**Subject:** **DRB CONDITIONS OF APPROVAL – FOLLOW UP  
MCLEOD MIXED USE PROJECT – FILE DRC07-00007**

### DESIGN RESPONSE CONFERENCE DESIGN REVIEW BOARD DECISION

**PROJECT NAME:** McLeod Mixed Use Project

**FILE NO.:** DRC07-00007

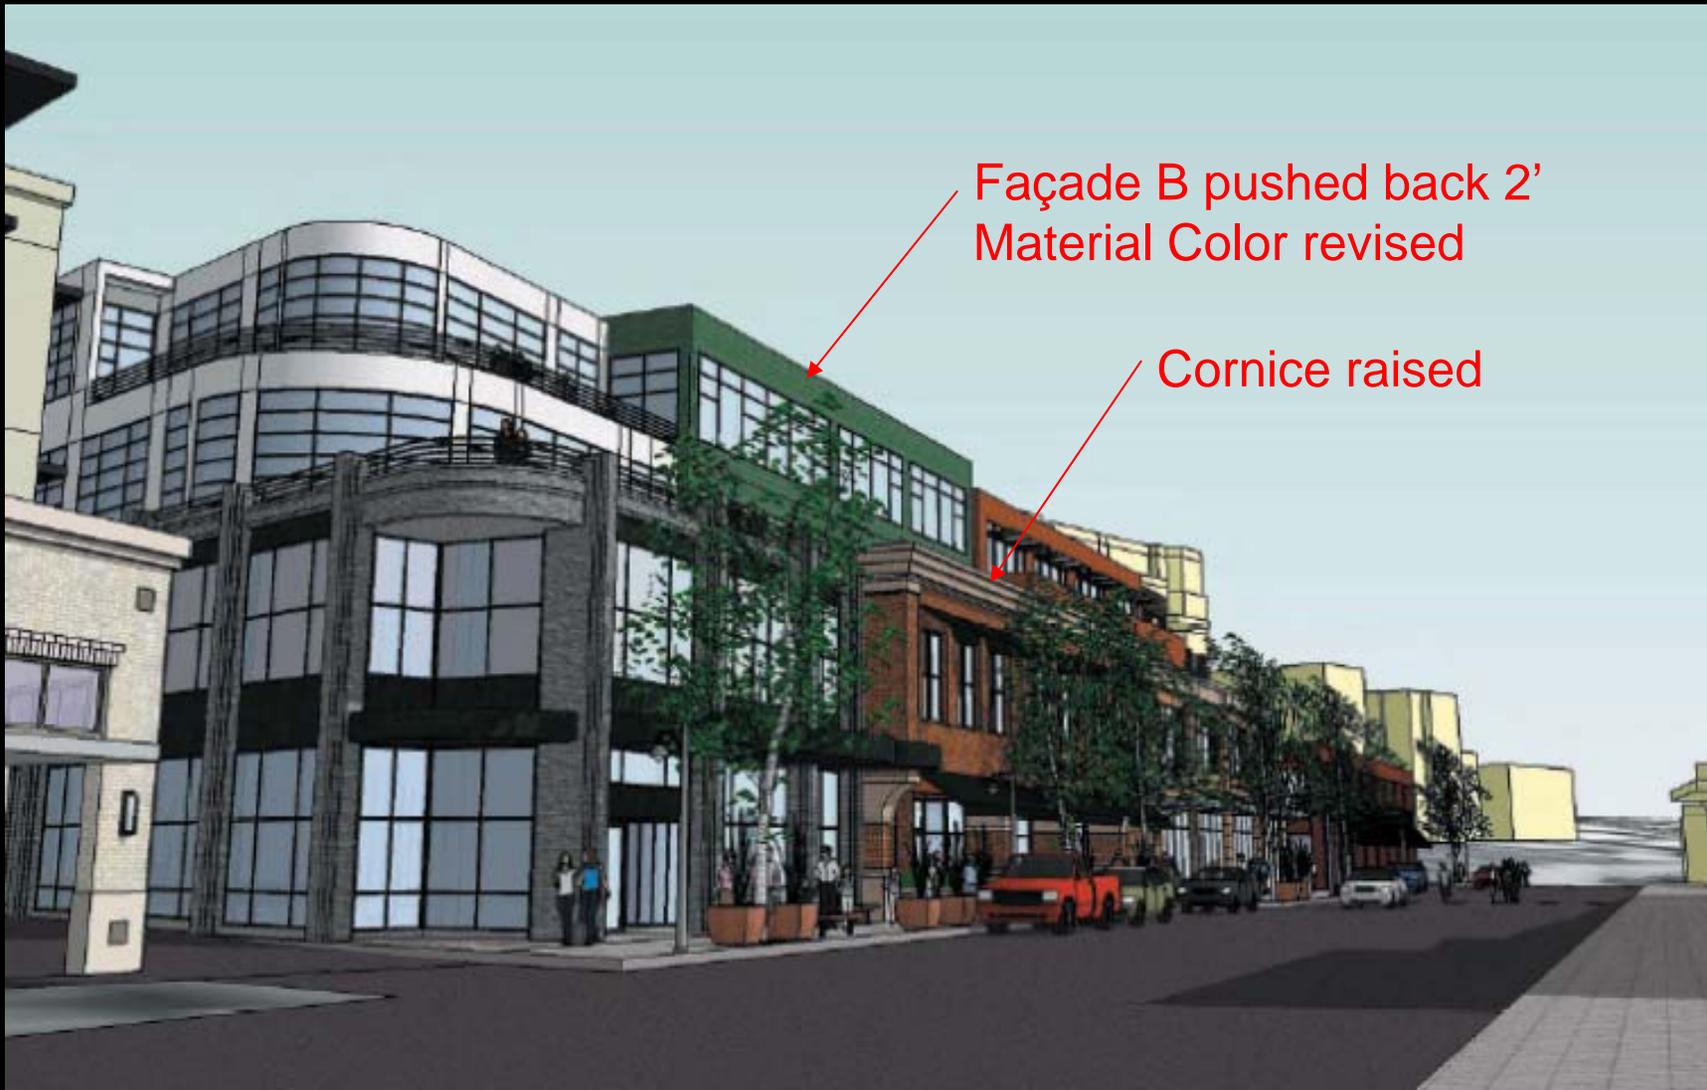
**CONDITION 1.** The 3rd and 4th story of Façade B (Hector's Façade) shall be set back an additional 2 feet. Also at the 3rd and 4th story on this façade, the sunshades shall be removed, a darker color is required, and the 2nd story cornice shall be raised to help further obscure the view of the upper stories from across the street at ground level.

- *The 3rd and 4th floors have been set back an additional 2 feet.*
- *The sunshades have been removed.*
- *A darker color (green not tan) has been used.*
- *The 2nd floor cornice has been raised up to guardrail height (3' – 6")*

Façade B pushed back 2'  
Material Color revised

Cornice raised

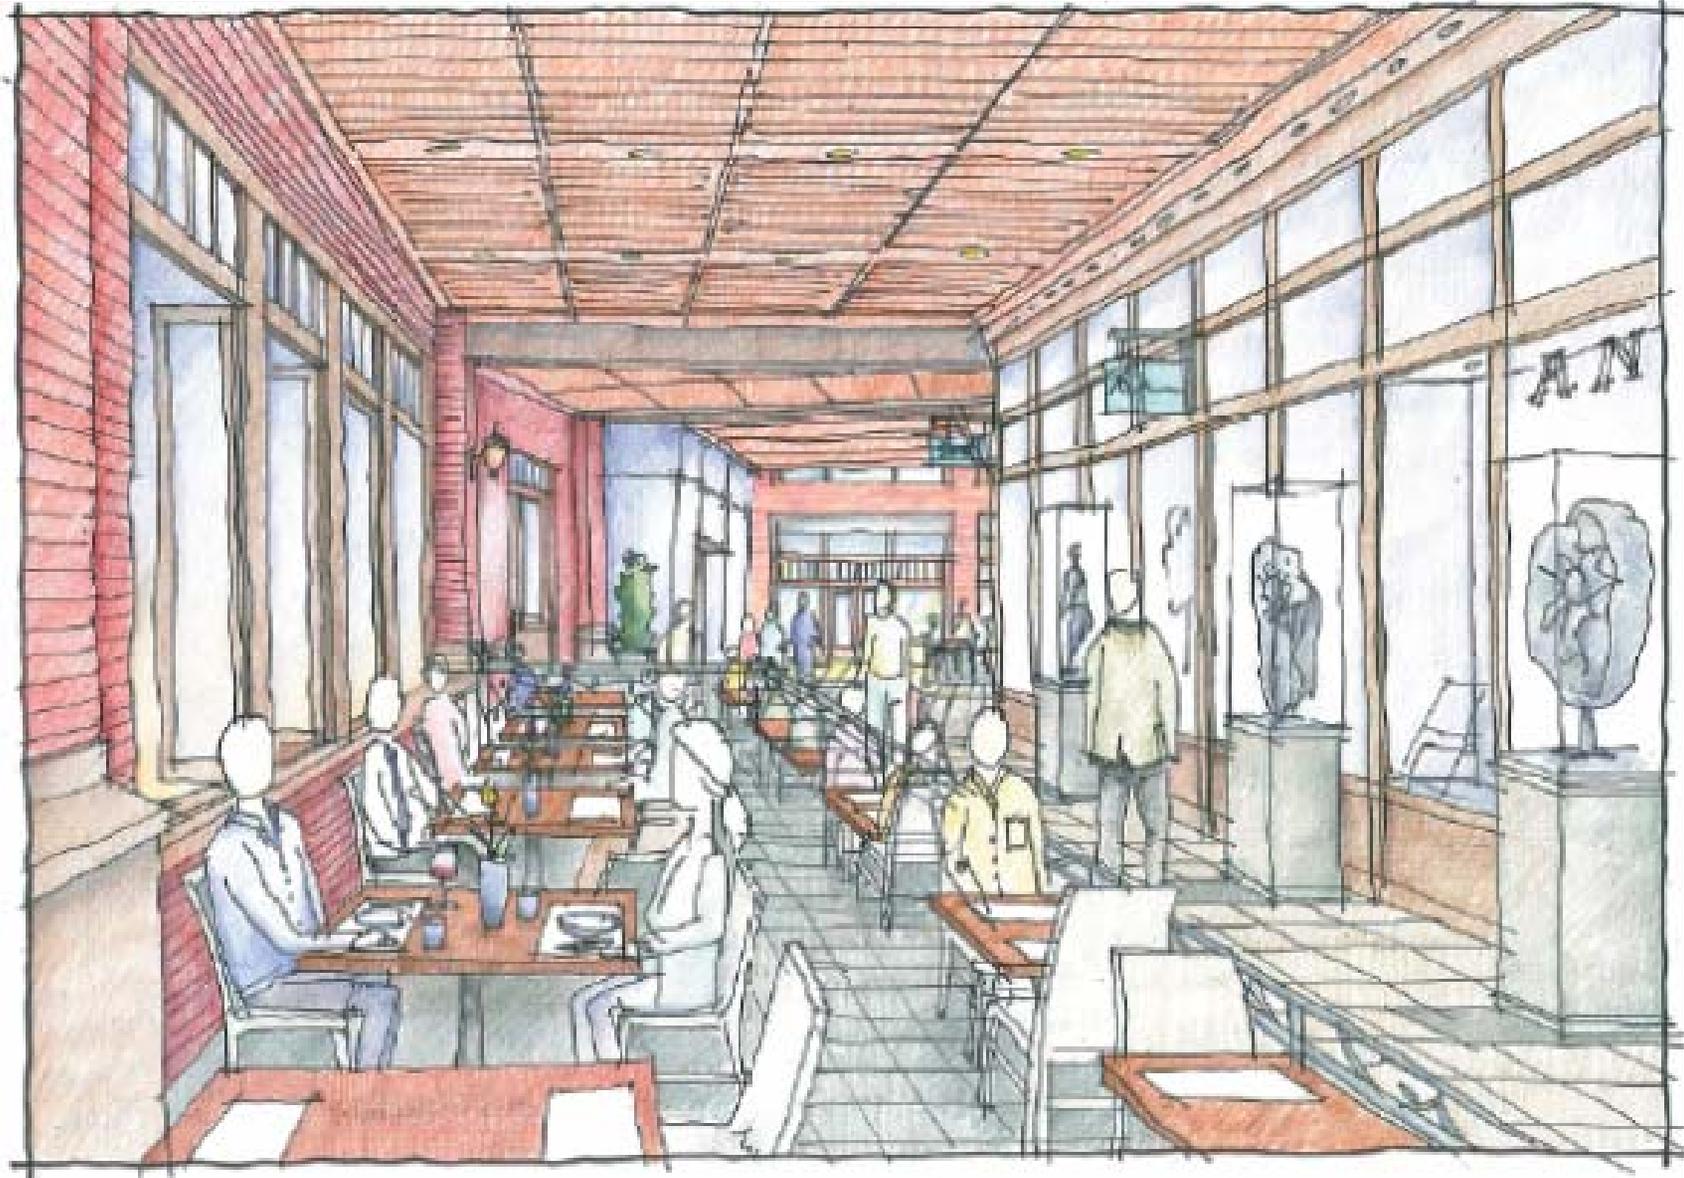
**CONDITION 4.** At Façade D, windows at the ground floor shall be redesigned to better reflect a balance between the design guidelines for larger street front windows and the need for meeting pedestrian scale guidelines encouraging varied window treatment.

- *Façade D windows will vary in the final designs by virtue of individual tenant improvements. The intention is to have as a base design, teak wood framed windows and doors for tenant storefronts as the baseline for design. The spandrel panels have been changed to add another material (tile of stone or ceramic)*
- *Additional studies indicate the intention to work with the Kirkland Cultural Council to develop art along the retail storefronts that include display systems and lighting that is integrated with the storefronts*

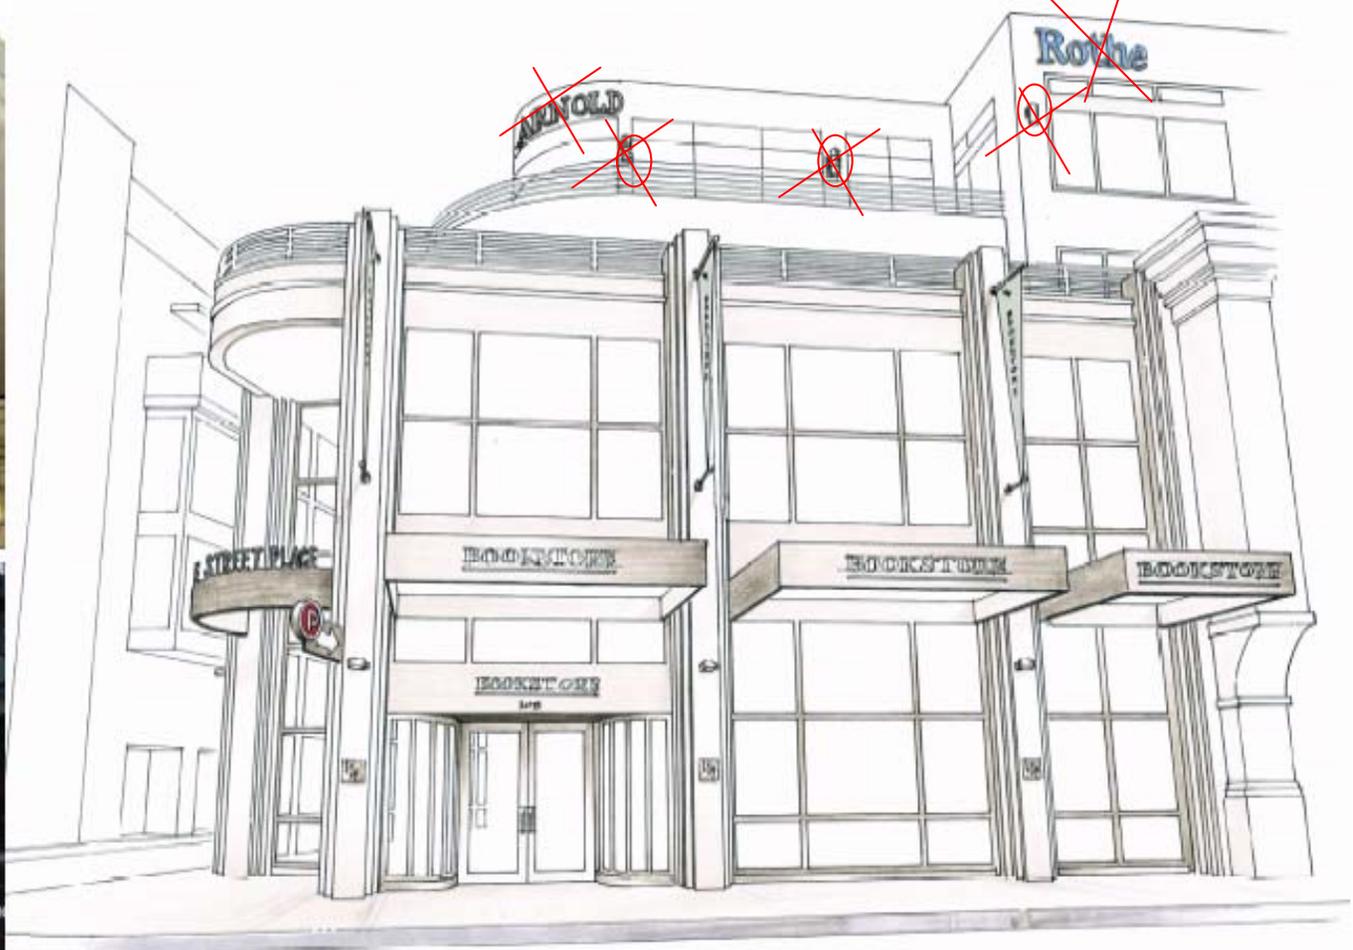
**CONDITION 8.** Building lighting is not allowed at upper stories except where required by the Building Code. Where lighting is required, light fixtures shall be directed inwards into the subject property.

•*Lighting will not be placed on the building above the 2nd story unless required by the Building Code. Where lighting is required by the Building Code above the 2nd story, lighting fixtures will not be visible at ground level, light will be directed into the subject property, and building facades will be lit to the minimum necessary to meet Building Code requirements.*

Conditions #9, #10, & #11

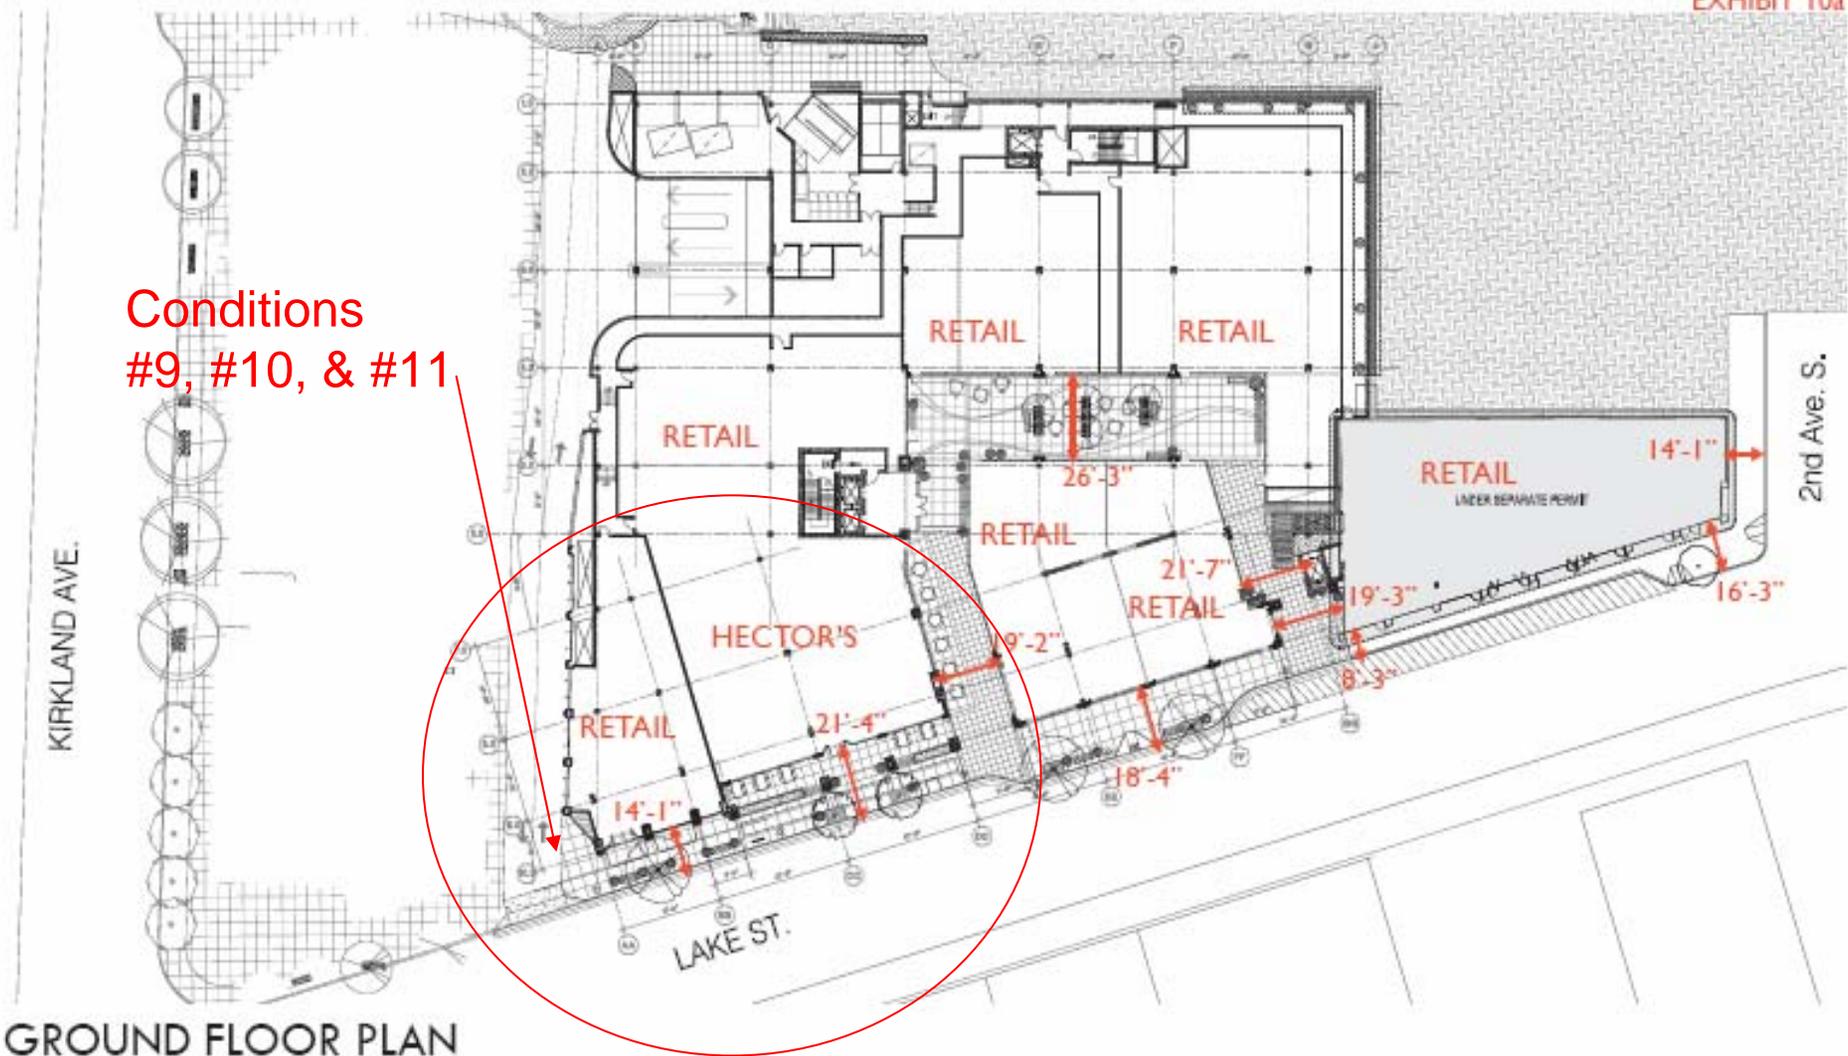
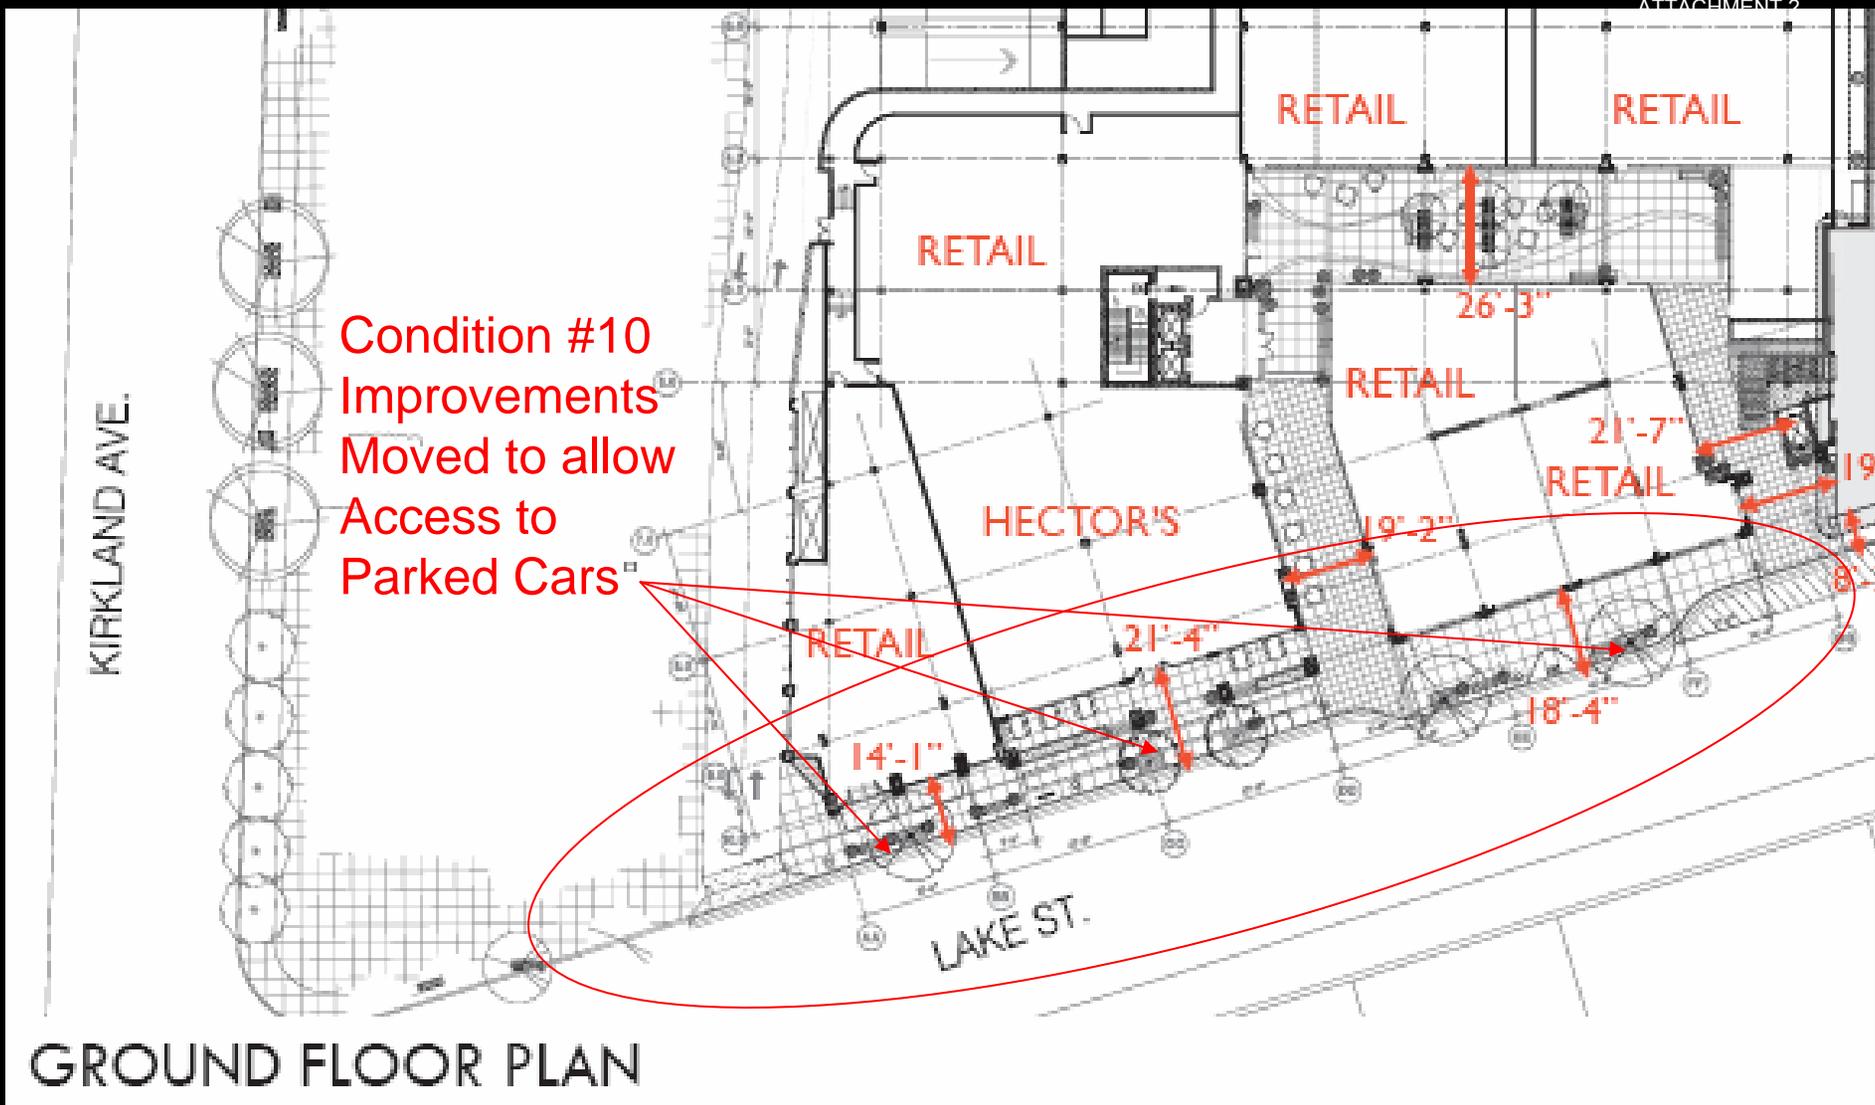
**CONDITION 9.** Bollards shown on the site plan shall be removed where Lake Street South sidewalk meets the alley.

**CONDITION 10.** Benches, vegetation, and other improvements where located next to on-street parking areas shall be removed.

**CONDITION 11.** A low profile planter shall be constructed in the northwest corner enclave to contain plants and seating.

- *The bollards have been removed from the sidewalk at the alley entry off Lake Street South.*

- *Benches, vegetation, and other improvements have been moved to create a clear dimension of 18" minimum adjacent to the curb to allow for pedestrian access to and from automobiles at the curb.*

- *A planter has been designed into the corner enclave at the northwest corner (in front of the corner retail at Façade A.*
